County of Loudoun
Department of Planning
MEMORANDUM

SUBJECT: ZMAP 2008-0021, Kincora Village Center – Second Referral

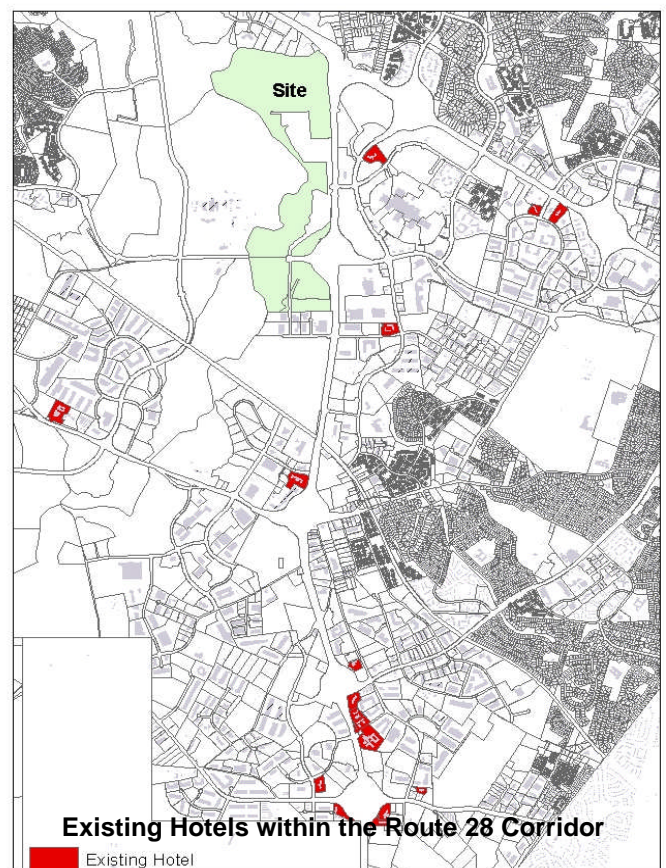
While the proposed linkage proffers include minimum floor area requirements for office uses as well as maximum floor area requirements for retail uses, staff notes the non-residential floor area may include the proposed 575,000 square foot of hotel uses as well as uses approved as part of SPEX 2008-0054, Kincora Village – Office/Recreational Complex. Based on the total square footage of residential uses proposed, staff can estimate the square footage per residential unit to determine the total amount of square footage proposed within each phase as shown in the table above. Therefore based on the linkage proffers IF1 and IF2 office development on the property may consist of approximately 19% and 53% of the total non-residential uses proposed within each phase respectively; however, when looking at the total square footage proposed within each phase the total office development on the property is only 8% in phase one and 27% in phase two. In addition, phase one only proposes 29% of the total non-residential uses proposed with the rezoning and special exception applications (4% of the total office uses proposed) while proposing 66% of the total residential uses and phase two proposes 30% of the total non-residential uses proposed with the rezoning and special exception applications (22% of the total office uses proposed) while proposing up to 93% of the total residential uses. It is the Plan's intent for office uses to be the predominant use in terms of percentage of the site occupied in all phases of development (*Revised General Plan, Chapter 11, Light Industrial and Regional Office Design Guidelines*). This is consistent with the Retail Plan's policy guidance which calls for the retail component of an office development to be developed on a pro-rata basis in proportion to the non-residential development as

construction occurs. For example, for every 100,000 square feet of office space constructed, 5,000 square feet of retail space may be constructed (*Retail Plan, Employment Supportive Retail Center Policy 3*).

Staff recommends revising phasing of the development to ensure that office uses are the predominant use in all phases of the development. This can be accomplished by reducing the amount of residential development in each phase and increasing the amount of office uses. Staff further recommends reducing the amount of retail in each phase so that it is developed in proportion to the non-residential development as called for in the Retail Plan. Staff recommends that in addition to revising phasing of the development, the applicant commit to developing higher intensity office uses fronting Pacific Boulevard in the early phases of the development to ensure that office uses are not only the predominant use on the site, but also the predominant feature when viewed from periphery roads.

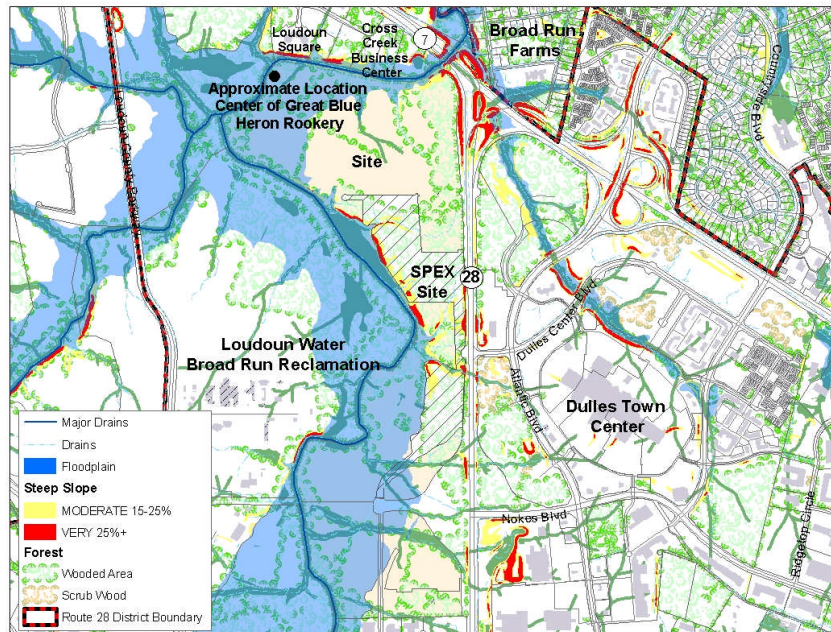
Retail and commercial service uses located in the ground floor of office buildings adjacent to Route 28, Pacific Boulevard, and Gloucester Parkway should be oriented away from these roadways so as not to attract “drive-by” shoppers. Retail uses should be integrated into office and residential buildings or located internal to the site and oriented towards the office and residential uses they are intended to serve. Staff recommends committing to retail uses internal to the site so as not to attract “drive-by” shoppers. Without commitments to the integration, scale, and intensity of retail and commercial service uses, staff cannot support retail uses above 136,110 square feet or 5% of the total office uses proposed.

Staff recommends revising the proffers limiting the size of retail uses to ensure they are of a scale that serves primarily the convenience needs of the business and residential uses. The proffers should also prevent freestanding retail and commercial service uses from being located along the Pacific Boulevard/Route 28 and Gloucester Parkway frontages. The application should also commit to design controls that ensure any free standing retail uses function appropriately as part of a pedestrian-oriented mixed-use development.
